21 September, 2015

Dr. Steven Bohlen
Division of Oil, Gas & Geothermal Resources
Department of Conservation
801 K Street, MS 24-02
Sacramento, CA 95814

ATTN: Aquifer Exemption

On behalf of the Natural Resources Defense Council ("NRDC"), which has 2.4 million members and activists, more than 380,000 of whom are Californians, we write to submit our comments on the proposal to expand the current aquifer exemption designation for the Dollie Sands of the Pismo Formation in the Arroyo Grande Oil Field located in unincorporated San Luis Obispo County, near the intersection of Ormonde Road and Price Canyon Road.

Figure 1: Site map showing the proposed aquifer exemption boundary (red line), the current aquifer exemption boundary (blue line), the non-compliant UIC wells, and compliant disposal and EOR wells.

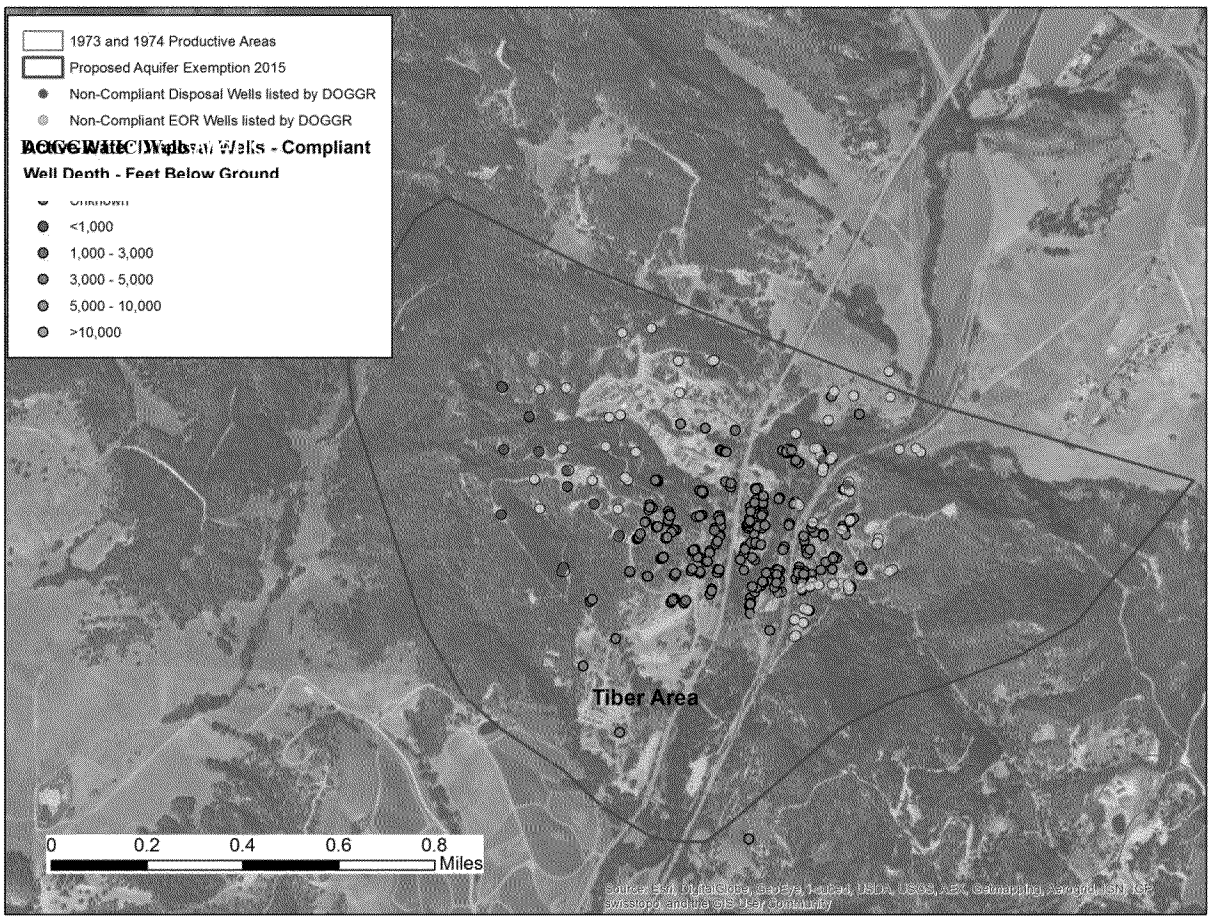
DOGGR and EPA have already exempted the hydrocarbon bearing zone, within the aquifer exemption boundary, as demonstrated in Figure 1. According to the 'List of Permitted Wells Sent to EPA'[10] spreadsheet, 14 disposal wells (green dots) and 76 EOR wells (pink dots), all of them non-compliant, are located within the proposed aquifer exemption ("AE") boundary (red line), yet outside of the currently exempted, hydrocarbon bearing aquifer boundary (blue line). The hydrocarbon bearing unit was based on a shapefile provided through DOGGR's FTP website, which delineated the spatial boundaries for the 1973 and 1974 oil productive units. However none of the active UIC wells located within the exempted, hydrocarbon bearing aquifer were listed in the 'List of Permitted Wells Sent to EPA' spreadsheet suggesting they are in-compliance with SDWA.

EPA must not grant an aquifer exemption for disposal wells based on 40 CFR §146.4(b)(1), for a non-producing portion of the aquifer that is also not demonstrated to be suitable for economical hydrocarbon recovery. While the applicant claims, "Hydrocarbons are distributed throughout the oilfield reservoir, both vertically and aerially" (page 3) the location, distribution, and recovery of the economically producible hydrocarbons are overwhelming located within the already exempted portion (blue line) of the proposed aquifer exemption (red line). Currently, the zone outside the boundary of the existing exemption is host mostly to disposal wells.
